P.O.A.D.P.  
OF  
T/S VENTURE

# POADP APPLICATION

Re: T - S Venture

POADP # 617

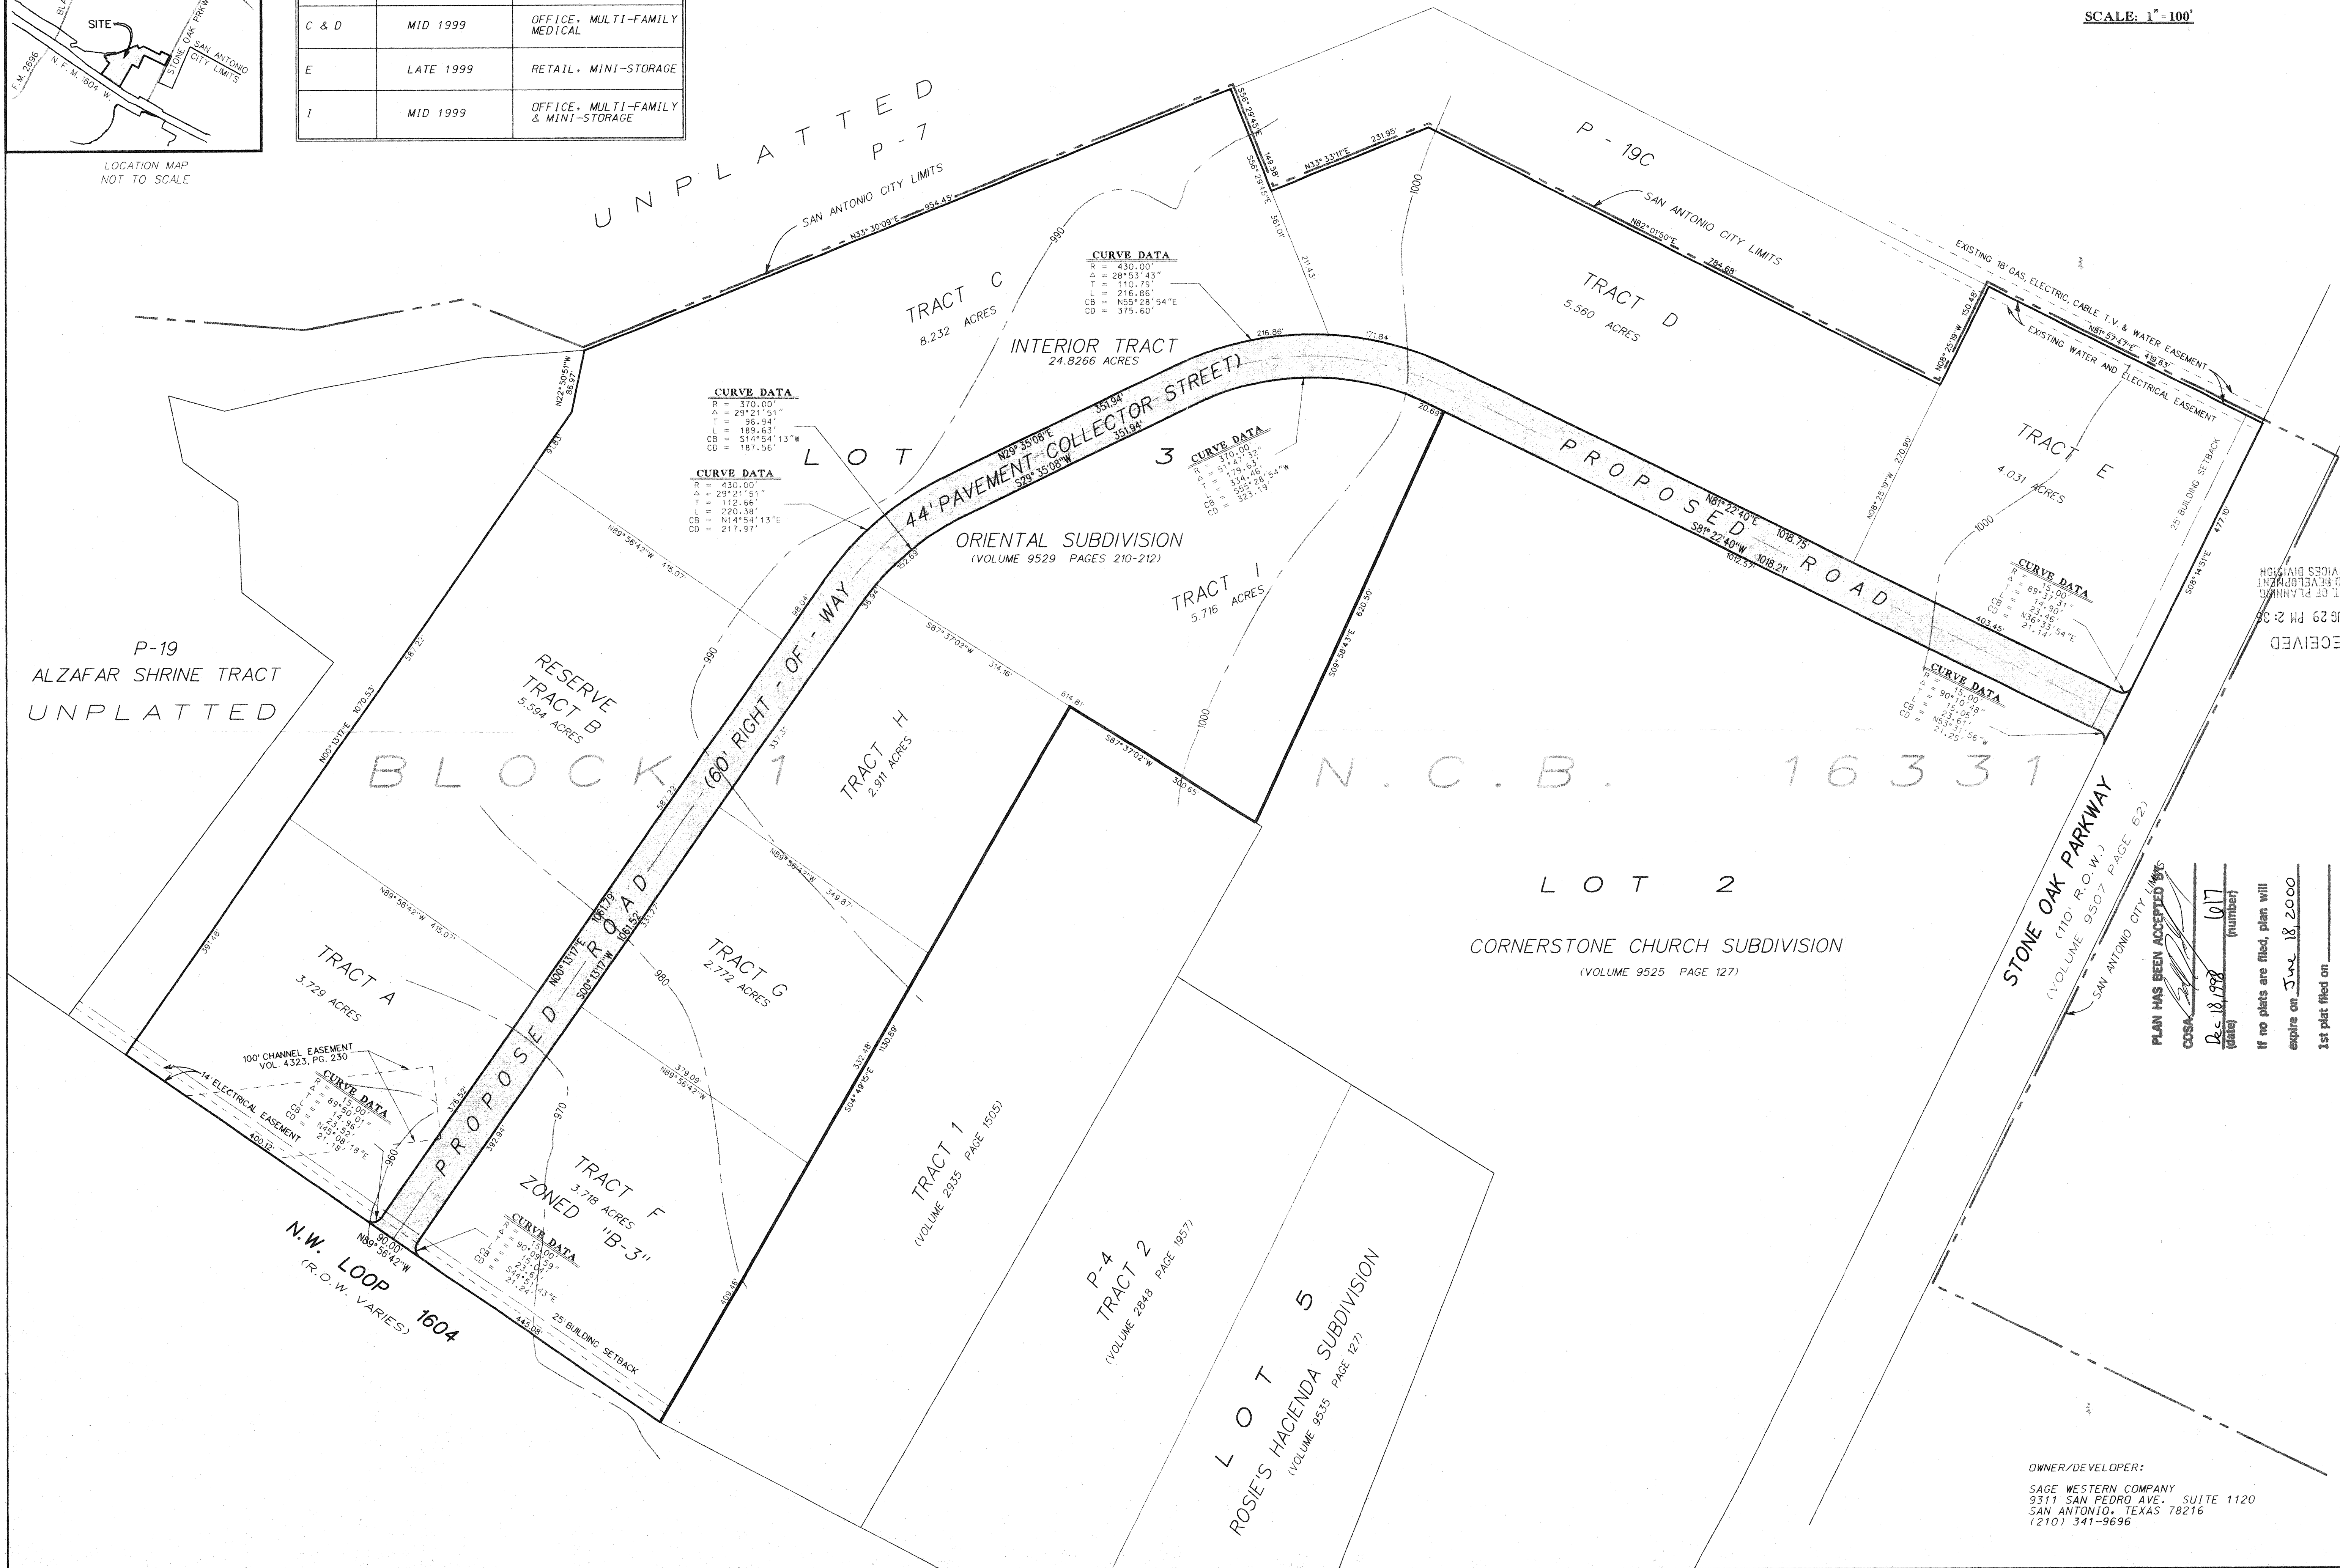
- Based on the topography, a Flood Plain Study and drainage review will probably be required during the platting process.
- This development will probably need to conform to requirements associated with development over the Edwards Aquifer. For additional information about these requirements you can contact SAWS at 704-7305.

- Access and R.O.W. issues along State facilities will need to be resolved with the Texas Department of Transportation (TXDOT). For information about these requirements you can contact TXDOT at 615-5814.

- This development will need to comply with tree preservation ordinance #85262. For information about these requirements you can contact Building Inspections at 207-7102.

- It will be expected that you will plat all of the property depicted in your POADP, to include: floodpains, drainage areas and open space.
- I would encourage you to work closely with the school district, so that they can plan accordingly.

For residential development directly adjacent to State ROW, the developer shall be responsible for adequate set-back and/or sound abatement.

50' ROW flares will be required at the intersection of the proposed road and Loop 1604.

This development is eligible for a maximum combined total of four(4) access points. Locations of access points will be as directed by "Regulations For Access Driveways to State Highways".

A complete copy of the approved WPAP will be required at the time of platting. State right of way will not be utilized for the purposes of treating storm water runoff from adjacent property.

Comments: Drainage easement will be require  
and will be address during the platting  
process.
